T-11159

Name Willow Farms, LLC
c/o Mark Zoller
Address PO Box 288
Washougal, WA 98671

Change in POU
Date Filed 11-29-10
Initial notice date 12-7-10
DPD issued date
PD issued date 2/7/13
PD notice date 2/14/13
Date of FO 3/21/13 Vol 39 Page 240

Reference: Application T- 11159

WILLOW FARMS, LLC
2010 TRANSFER OF CERT 75806
TOWNSHIP 2 NORTH, RANGE 23 EAST,
WILLAMETTE MERIDIAN
MAP 2 OF 8

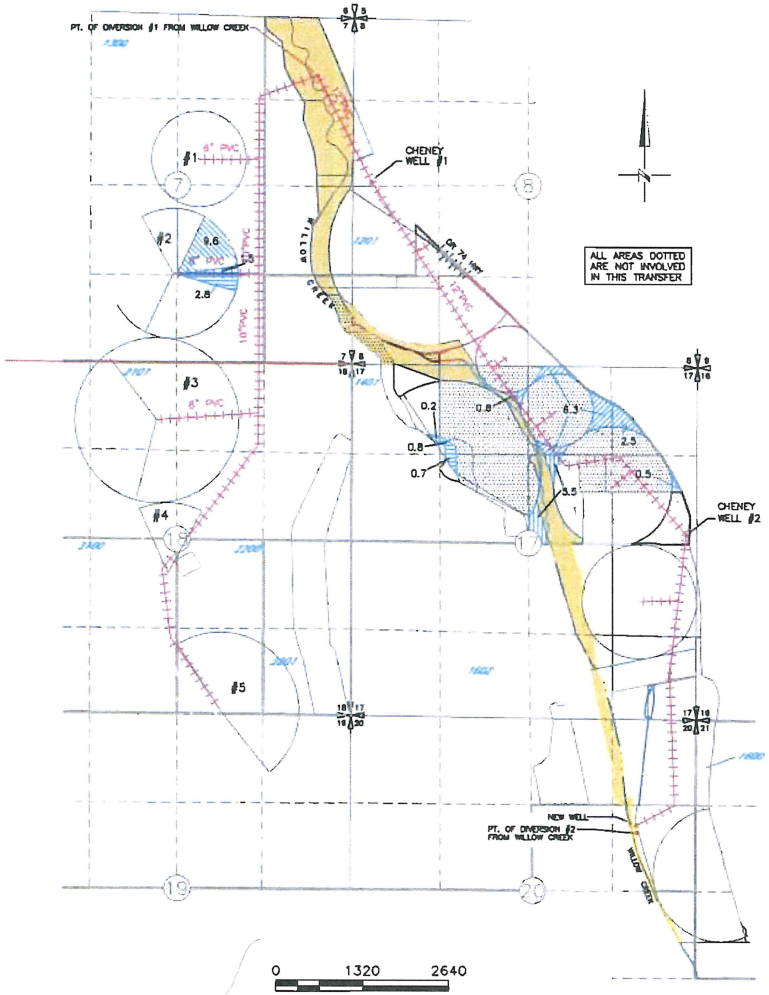
- on Map 2 of 8, as noted above, please change the hachuring for the 1892 designation of the 0.8 acres in the NE¼ NW¼, of Section 17. This would then require you to correct the total acreage amounts in your Key /Legend to the right.
